UNITED STATES DEPARTMENT OF COMMERCE United States Patent and Trademark Office Address: COMMISSIONER FOR PATENTS P.O. Box 1450 Alexandria, Virginia 22313-1450 www.uspto.gov

APPLICATION NO.	FILING DATE	FIRST NAMED INVENTOR	ATTORNEY DOCKET NO.	CONFIRMATION NO.
10/551,147	09/22/2005	Robert Bruce Grant	MO2B166	3951
71134 Edwards Vacuu	7590 02/20/200 ım. Inc.	EXAMINER		
55 MADISON	,	RIPA, BRYAN D		
	Suite 400 MORRISTOWN, NJ 07960			PAPER NUMBER
			4111	
			MAIL DATE	DELIVERY MODE
			02/20/2009	PAPER

Application No.	Applicant(s)					
	10/551,147	GRANT ET AL.					
Office Action Summary	Examiner	Art Unit					
	BRYAN D. RIPA	4111					
The MAILING DATE of this communication app Period for Reply	pears on the cover sheet with the c	orrespondence address					
A SHORTENED STATUTORY PERIOD FOR REPL' WHICHEVER IS LONGER, FROM THE MAILING D.  - Extensions of time may be available under the provisions of 37 CFR 1.1 after SIX (6) MONTHS from the mailing date of this communication.  - If NO period for reply is specified above, the maximum statutory period of Failure to reply within the set or extended period for reply will, by statute Any reply received by the Office later than three months after th

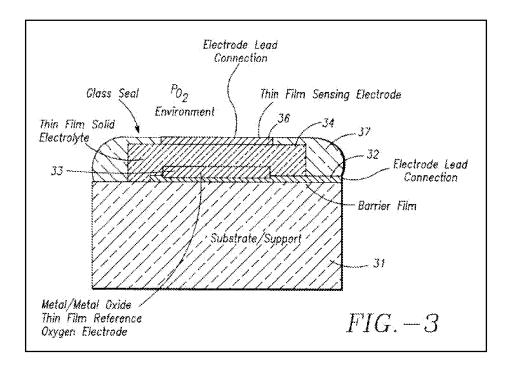
Regarding claim 1, GUR teaches a contaminant molecule sensor capable of use in a vacuum environment (see col. 3 lines 14–24) wherein the sensor comprises an electrochemical cell (see figure 3 below) having a measurement electrode (sensing electrode 36), a reference electrode (33), a solid-state ionic species conductor (solid electrolyte 34) bridging the measurement electrode and the reference electrode, and a means for initiating the catalysis of the dissociation of the reference and contaminant molecules (see col. 4 lines 1–5, 29–37; col. 4 lines 48–54). See figure 3 below.

Regarding claim 8, GUR teaches the contaminant molecule sensor having a vacuum feed-through connection for providing an electrical connection to the measurement electrode (see figure 3 above depicting the sensing electrode lead connection).

Regarding claim 9, GUR teaches the contaminant molecule sensor comprising seals for connection to a vacuum environment (see figure 3 above depicting the outer edge of the sensor).

Regarding claim 11, GUR teaches the contaminant molecule sensor wherein the reference environment space (the space corresponding to reference electrode 33 in figure 3 above) is at least partially bounded by the reference electrode and is enclosed by a seal (see glass seal 37 in figure 3 above).

Regarding claim 12, GUR teaches the contaminant molecule sensor with the electrical cables for connecting the electrodes and optionally the electric heating means with an electrical circuit passing through the seal (see figure 3 above showing the electrode lead connections for both the reference and the sensing electrode passing through the glass seal).

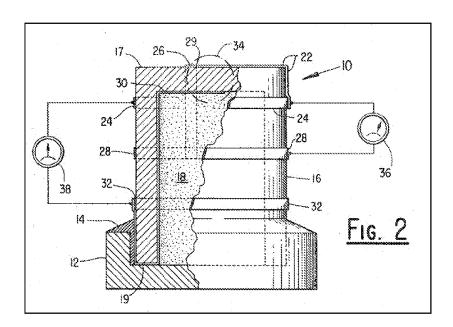
Regarding claim 1, FLAIS teaches a contaminant molecule sensor capable of use in a vacuum environment wherein the sensor comprises an electrochemical cell (see figure 2 below) having a measurement electrode (electrode strip 22), a reference electrode (electrode strip 30), a solid-state ionic species conductor (electrolyte tube 16) bridging the measurement electrode and the reference electrode, and a means for initiating the catalysis of the dissociation of the reference and contaminant molecules (see col. 3 lines 48–50; col. 5 lines 42–55). See figure 2 below from FLAIS.

Regarding claim 2, FLAIS teaches the contaminant molecule sensor wherein the means for initiating the catalysis of the dissociation of the reference and contaminant molecules comprises means for controlling and monitoring the temperature of the cell (see col. 5 lines 42–55 describing the use of the heater control element to operate the sensor at a set point temperature).

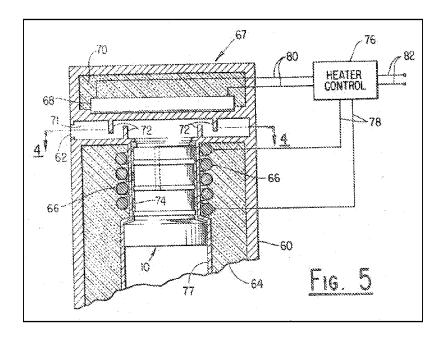
Regarding claim 3, FLAIS teaches the contaminant molecule sensor having a means for separating a reference environment space from a monitored environment space (see figure 5 below depicting the reference environment space as that space surrounded by detector jacket 60 on the bottom portion of the figure and the monitored environment space as unknown atmosphere chamber 71), where the means for controlling and monitoring the temperature of the cell includes a heating device contained within the reference environment space (see circumferential heater 66).

Regarding claim 5, FLAIS does teach the electrically powered heater (circumferential heater 66) being a wire-type heater (see figure 5 above from FLAIS), but does not explicitly teach the wire being NICHROME™.

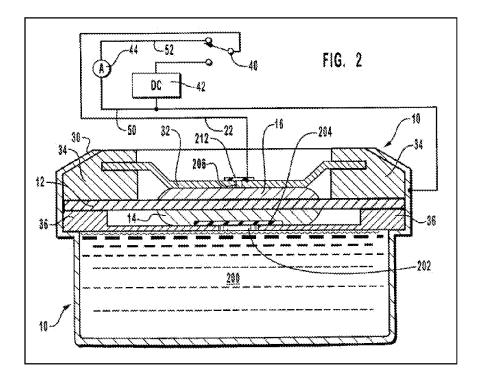
Regarding claim 1, SHEN teaches a contaminant molecule sensor capable of use in a vacuum environment wherein the sensor comprises an electrochemical cell (see col. 4 lines 20–28) having a measurement electrode (sensing electrode 16), a reference electrode (counter electrode 14), a solid-state ionic species conductor (protonic conductive membrane 12) bridging the measurement electrode and the reference electrode, and a means for initiating the catalysis of the dissociation of the reference and contaminant molecules (see col. 9 lines 14–40 discussing the making of counter electrode 14 and sensing electrode 16 with a platinum thin film). See figure 2 below.

Regarding claim 11, SHEN teaches the contaminant molecule sensor wherein the reference environment space (the space surrounding reservoir 200) is at least partially bounded by the reference electrode (counter electrode 14) and is enclosed by a seal (see the configuration of washer 36 placed in can 30 in combination with cap 32 which act as a seal to enclose the reference environment space). See figure 2 above.

Regarding claims 21, SHEN teaches the contaminant molecule sensor having in the reference environment space a liquid state source of the ionic species (see col. 7 lines 3–5 discussing reservoir 200 being filled with deionized water providing hydrogen ions for the electrochemical detection of the analyte gas). See figure 2 above.

Regarding claim 25, SHEN teaches the contaminant molecule sensor where the solid-state ionic species conductor (protonic conductive membrane 12) conducts hydrogen ions. See figure 2 above from SHEN.
